Subject: Response to NRC Questions  
Comanche Peak Steam Electric Station  
Independent Assessment Program - Phases 1 and 2  
Texas Utilities Generating Company  
Job No. 83090

## GENERAL NOTES TO PIPE SUPPORT CHECKLISTS

### 3. Local Stress Effects

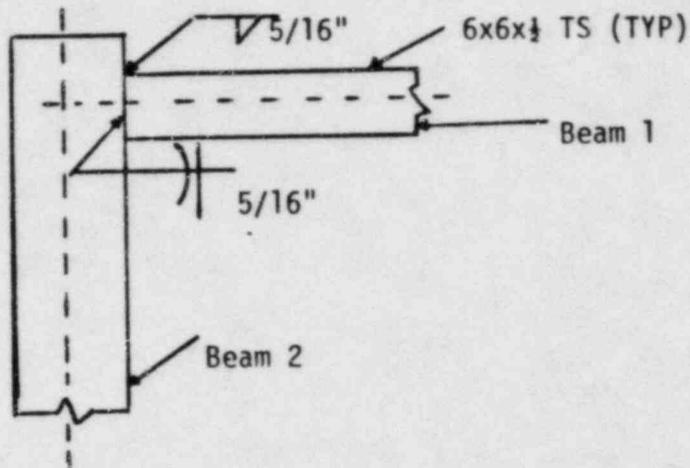
In reviewing the pipe supports for Phase 3, Cygna noted many instances of the following:

- a) Use of wide flange or back to back channels without stiffener plates at connections and without calculations to show the joint is acceptable.

- b) Use of tubesteel in frames without checking whether the webs of the tube are adequate to transmit the load, especially when the end is a load transfer point.
- c) Use of composite sections, made up by welding a plate to a tube section, without considering the additional stress in the weld at the load transfer point (**see Observation PS-07**).

"Although the various design guidelines may not require that specific calculations be performed on structural connections the effects of localized stress are often evaluated with approximate calculations. The individual design engineer assesses each situation on a case-by-case basis. From his inspection, he may judge the effects negligible or may add gussets or stiffeners; or he may elect to calculate the actual stresses and determine if there is a necessity for stiffening. In all cases, however, the designer is guided by the limits set forth in subsection NF and specification MS-46A. It has always been a matter of good engineering practice to make these considerations. It is not industry practice to provide guidelines to engineers for these considerations, nor is it necessary."

Cygna has reviewed each design in Phase 3 for the acceptability of the engineering judgment noted. In certain cases, Cygna was able to confirm that judgment since the applied loads were small. In other cases, Cygna performed their own calculations to determine the adequacy of the joint. In no case did Cygna find a design error, i.e., each joint would transfer the applied loads. It is the lack of calculations or notes in the design calculations that has caused Cygna to make this comment. Without at least a statement such as: "connections OK by judgment", Cygna had no way of knowing whether certain joints had been checked or not. Conversely, if stiffeners were added to a joint without calculations, Cygna had no means of determining that the stiffeners were properly designed, without performing our own calculations. Thus, while the lack of calculations in this area made the review more difficult, Cygna did not find any instances of overstress due to inadequate engineering judgment.

## 6. Tubesteel Prying on Richmond Inserts

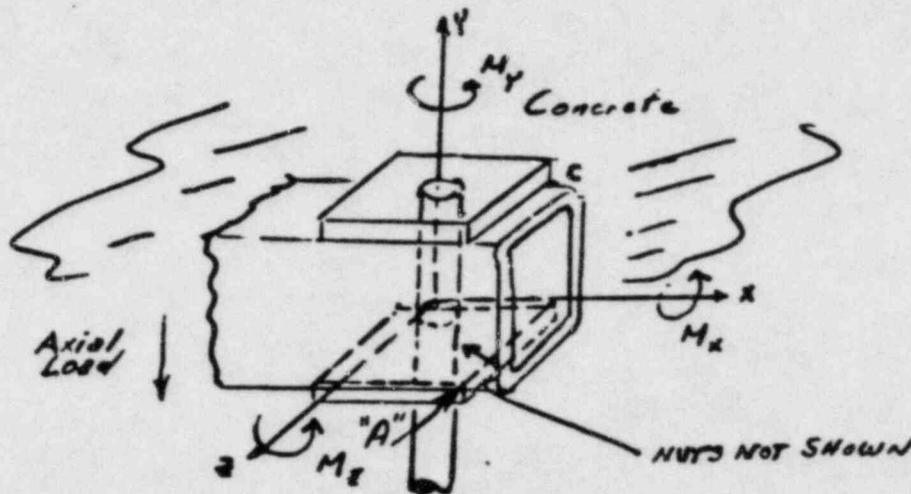
In the designs which employ tubesteel/Richmond insert combinations, Cygna noted that the engineer released the rotation about the Y and Z axes (see sketch) in the STRUDL model for the frame. While release of the Y rotation is appropriate since the bolt is free within the tube, release of the Z rotation assumes that the tube will not bear against the washer at point "A" and create a load due to prying on the bolt. TUGCO has provided justification for this and other analytical assumptions (i.e., the bolt does not carry any load in bending; the effect of bolt hole offset on bolt load) by performing both testing and analysis. Details of the justification may be found in the TUGCO letter dated 5/8/84 and in the "Affidavit of John C. Finneran, Jr., Robert C. Iotti and R. Peter Deubler Regarding Design of Richmond Inserts and their Application to Support Designs." In the letter to Cygna, TUGCO shows that prying due to rotation about the Z axis is not present when only vertical loads exist. When torsional moments ( $M_x$ ) exist, the study done by TUGCO shows that even with small amounts of torsion (1000 in-lb vs 40000 lb tension load), the effect of prying is due to torsion, with no contribution from moments about the Z axis. For large torsional loads (4000 in-lb vs. 2000 lb tension), the same effect holds true. Cygna then reviewed all tubesteel/Richmond insert joints within their scope and determined that the configuration analyzed by TUGCO (4 x 4 x 3/8 TS with 20" bolt spacing) is representative of the most flexible configurations and, therefore, most conservative. As a result, Cygna finds the method used by TUGCO to model these connections is acceptable.
